**PENRHOS, CAE GLAS & KINGSLAND, HOLYHEAD**

**APPLICATION NUMBER 46C427K/TR/EIA/ECON**

**IOACC COMMENTS 28.02.13 - PLANIT RESPONSE**

Figure 1: Penrhos Leisure Village,  
Design and Access Statement, November 2012  
Page 89

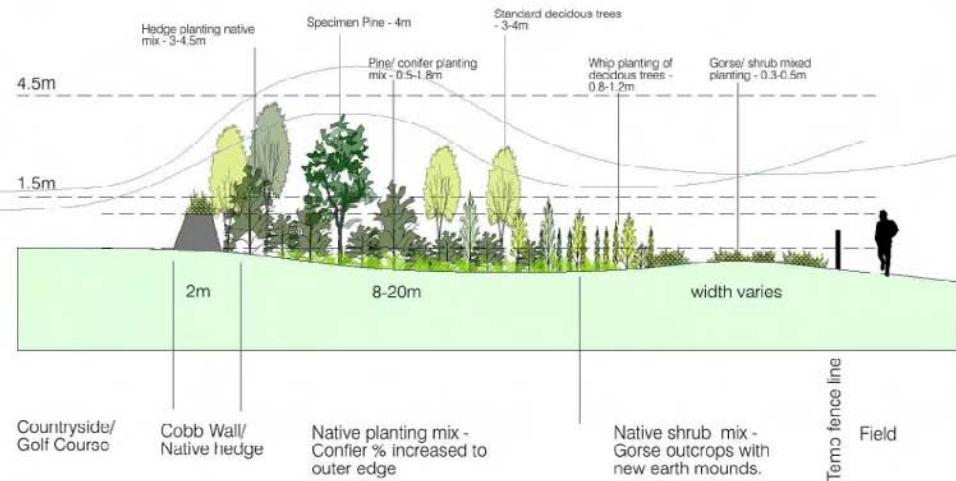
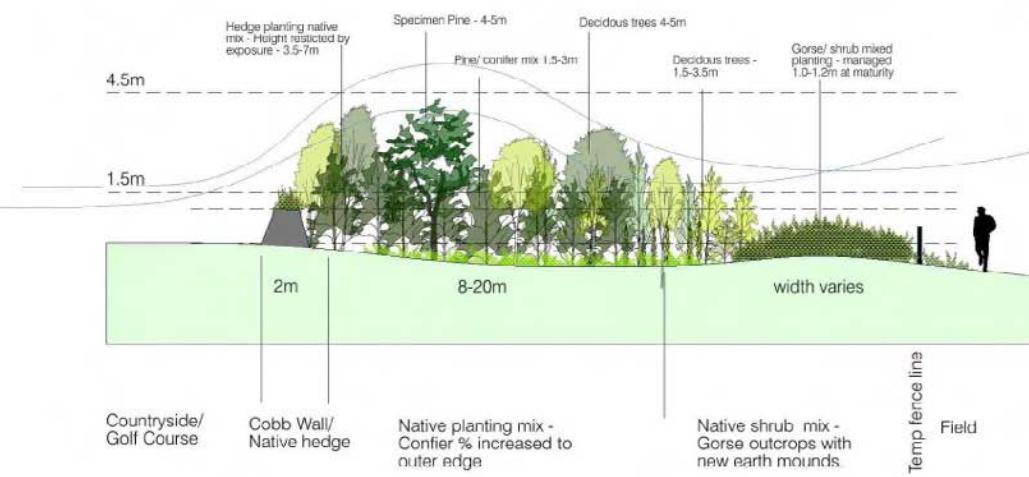
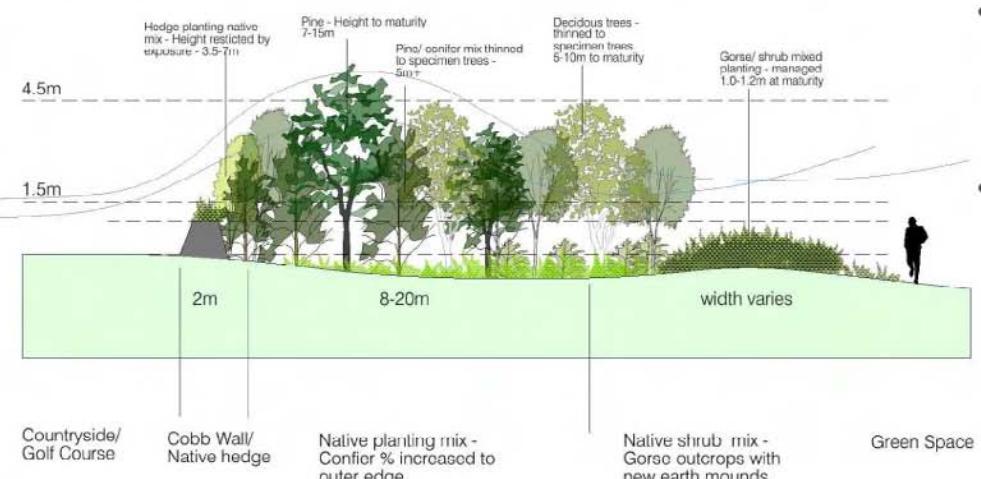
3.5 I would recommend that a significant depth of woodland edge/screen planting is retained to maintain character/safeguard screening at the Penrhos site and that this woodland screen is protected by a preservation order/management plan for mitigation purposes.

The Penrhos Design and Access Statement (D&A), produced as part of the application, provides indicative detail on how proposed woodland buffers will be established to provide screening of headland lodges.

The page opposite, extracted from page 89 of the D&A, illustrates a potential planting regime to promote establishment from year 1 to 10+. In conjunction with a new management plan, this provides a robust structure of planting and fencing to provide a protected woodland zone that will mature into a species rich block with associated field and grassland layers. These new areas of woodland will be invaluable in helping to screen views into the site and creating green buffers to adjacent land uses.

A long-term management plan for retained woodland will ensure continuity of canopy cover and increase tree-related values. The security of a sustainable business model will provide the required funding to improve and maintain the structure of retained woodlands/plantation. An absence of any such management would allow a steady decline in value, before the natural cycle of self-sustaining woodland could be established.

Figure 6: Penrhos Leisure Village, Design and Access Statement, November 2012, page 103

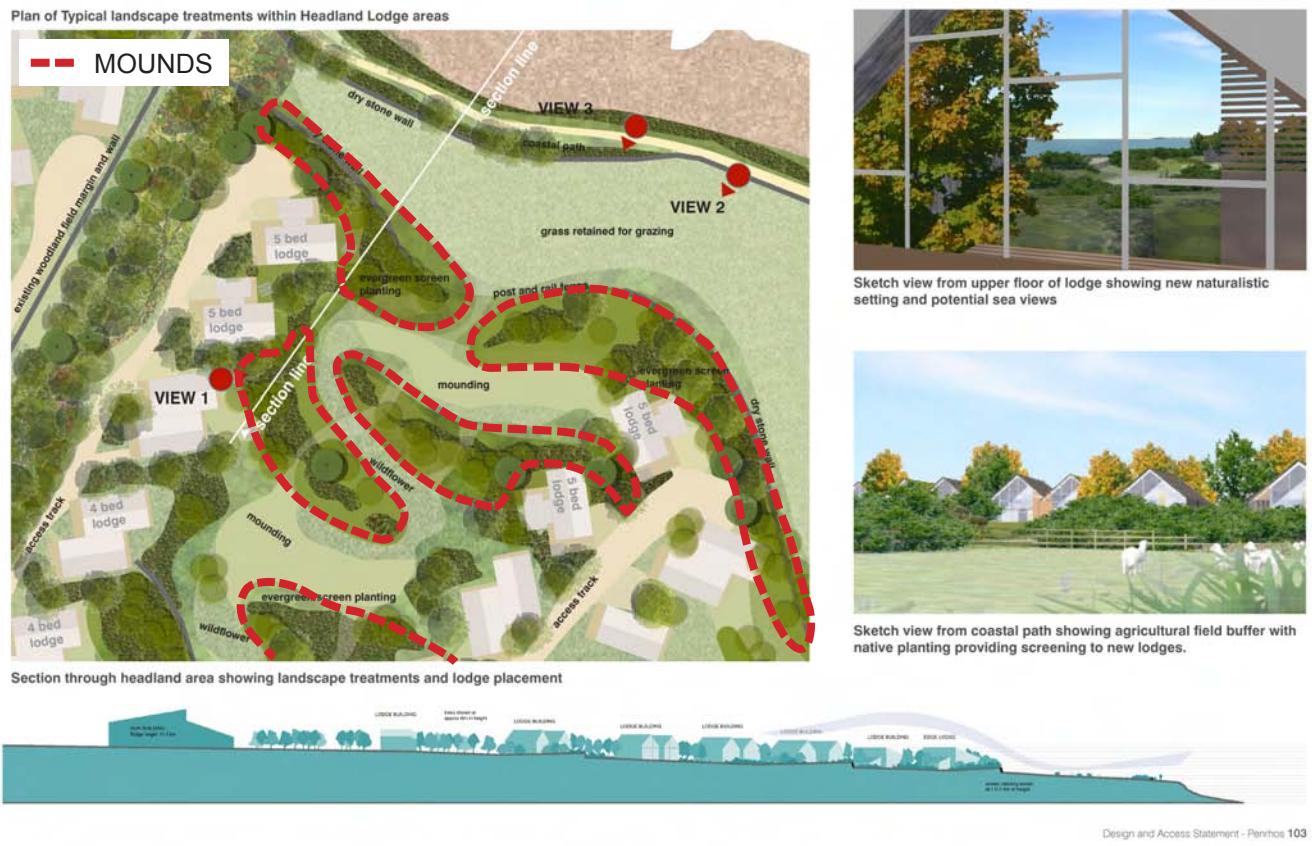
7.1 I would recommend further information/guidance is provided on the landscape proposals in particular the areas of new screen planting and mounding to better understand the mitigation proposals.

Figure 6 opposite shows page 103 of the Design and Access Statement, and provides an illustrative detail area of the Penrhos headland. The drawing shows in some detail the approach to screen planting and mounding. The key principles include arranging lodges in a horse shoe layout, with mounding, dry stone walls and planting of native trees and shrubs around the lodges to provide partial screening and filtering of views from the coastal path, and more distant viewpoints. It is not the intention that the mounds, planting and walls will entirely screen the lodges, as this would result in a significant visual barrier and change to the existing open character of the headland. Instead, the lodges form a high quality element within the view, and the associated planting, mounds and walling serve to embed the lodges in the landscape. Broad compliance with the principles of screening as set out within the D&A can be a condition of the planning permission.

Figure 7: Penrhos Leisure Village, Design and Access Statement, November 2012, page 86

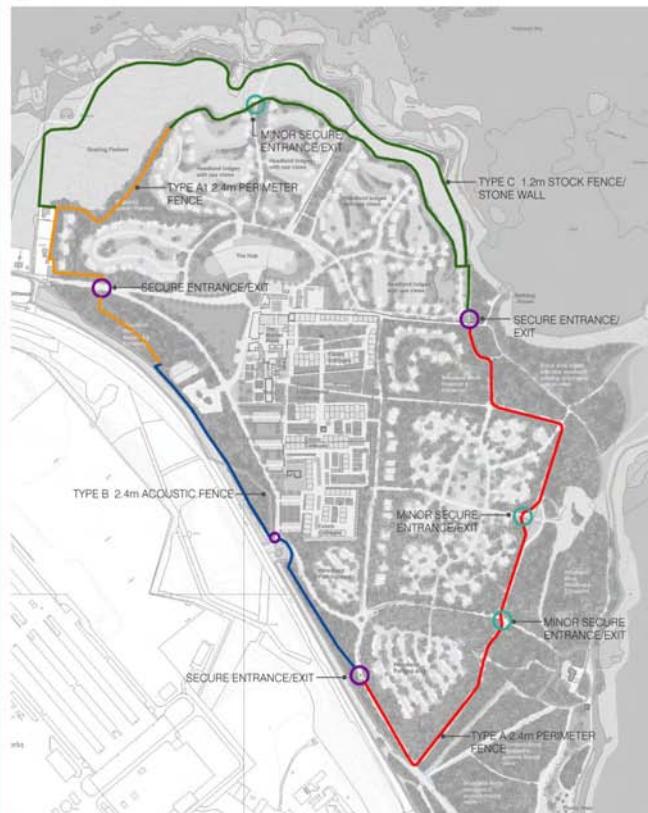
10.2 An explanation of controlled public access would be useful and how this is to be achieved.

The D&A which accompanies the application contains site security diagrams with illustrative sections to demonstrate how secure boundaries can be accommodated without negative impacts on landscape character and views. The site security diagram and sections for the Penrhos site are illustrated opposite, and form pages 86 and 87 of the D&A.
